1 Purpose of Document

This document summarizes the changes between the previous AS14U silicon revision C and the current silicon revision E. These include requested UART design changes. The purpose of the redesign was to correct reported timing errors by the UART in the following modes: Master, Monitor, and Repeater. A problem with slave communication in special network constellations was also fixed.

Figure 2.1 Comparison of Valid MAN-Code Signal to Faulty MAN-Code Signal

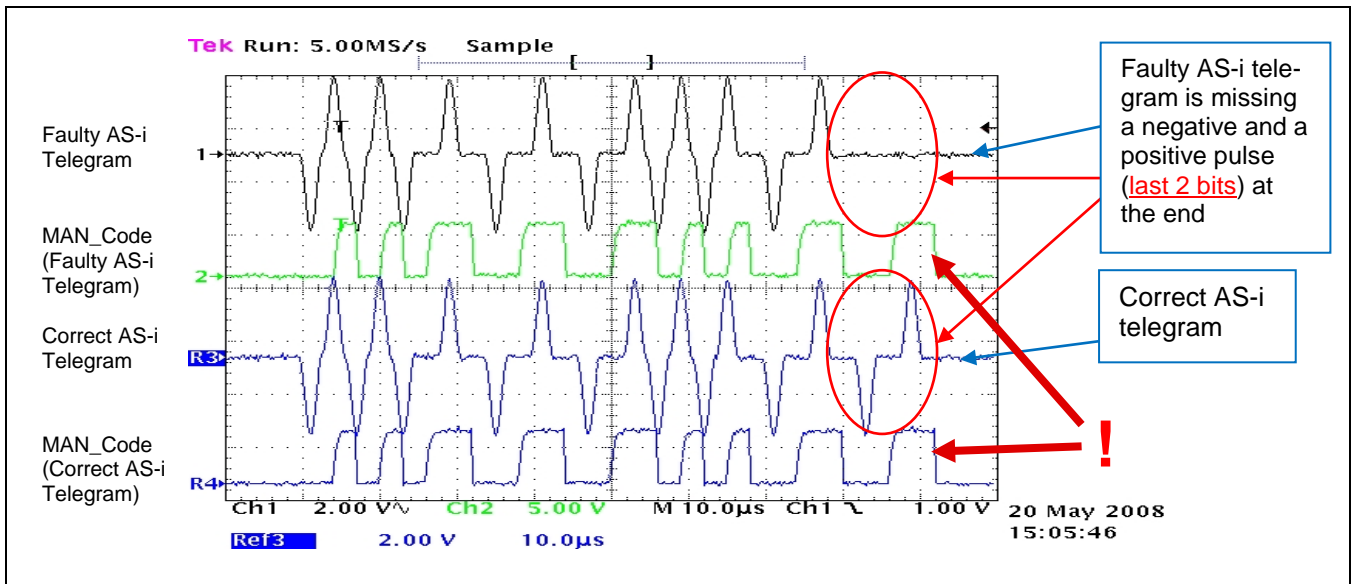
If the AS14U revision C operates in Master Mode, Monitor Mode or Repeater Mode, the error signaling for an *End_Bit_Error* does not work correctly. In some special cases, the generated MAN-Code of a signal with an *End_Bit_Error* looks similar to the MAN-Code of a signal without any errors as demonstrated in Figure 2.1.

This malfunction of the AS14U revision C results in an MAN-coded output signal that does not allow distinction between correct AS-I pulse sequences and pulse sequences that are shortened (missing one negative and one positive pulse). It occurs only under the following conditions:

- The parity of the signal is even.
- The last bit of the corrupt telegram is equal to binary 1.
- The *Stop_Bit* and the *Parity_Bit* or the *Start_Bit* and the *Control_Bit* are missing.
- If the *Start_Bit* and the *Control_Bit* are missing, the first pulse must have a negative polarity.

1. The last pulse of the MAN-coded LED1 output signal is now always kept in ACTIVE state for 9 μ s if an ASI telegram with an *Endbit_error* is received.

The polarity of the ACTIVE State depends on the signal setting at the DI ports in Master Mode, Monitor Mode, and Repeater Mode. If DI2 and DI3 are driven by equal input signals, the MAN output signal at LED1 is configured ACTIVE LOW. If DI2 and DI3 are driven by unequal input signals, LED1 becomes inverted and is configured ACTIVE HIGH.

Since a 9 μ s-wide MAN pulse is an out-of-specification event for the AS-I MAN signal, it will allow the connected microcontroller to recognize the error in the AS-I pulse signal on the AS-I line.

Figure 3.1 Test for ASI4U Revision C Error in Master Pause Detection

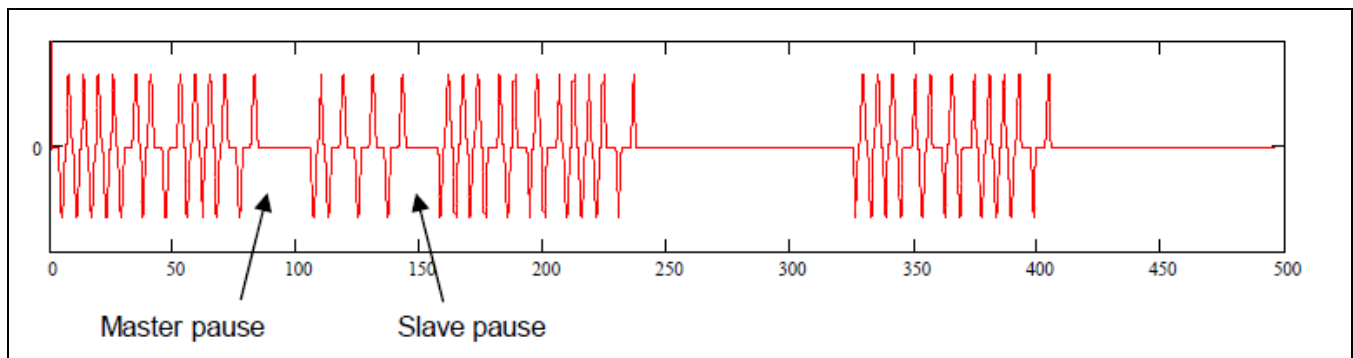
If the previous ASI4U revision C is operated in Slave Mode, the UART Master Pause detection does not always function correctly when the UART must listen to slave responses from a different slave. Depending on the actual AS-I line pulse timing, a slave response from a different slave is sometimes not recognized correctly, which results in a UART communication error. This prevents the Slave from understanding the next Master telegram correctly. If the Master telegram addresses the Slave itself, the error leads to a missing slave response and the Slave replies on a second repetition of the Master Call to its own address in asynchronous mode.

Figure 3.1 shows a telegram test case to reproduce the error. The AS-I signals shown in Figure 3.1 were generated by a signal generator that allowed sweeping the Master Pause and Slave Pause duration over the allowed specification limit. The first Master Call contains a different slave address than the tested slave. The second and third master calls address the tested slave. The tested slave replied with the erroneous behavior for certain Master pause and Slave pause scenarios only. The majority of the test cases were passed without error.

A new principle of AS-i telegram pause detection was implemented in ASI4U silicon revision E that is more precise and able to cover all valid timing scenarios for Master and Slave pauses. The new principle is now independent of the internal timing constraints of the UART state machine.
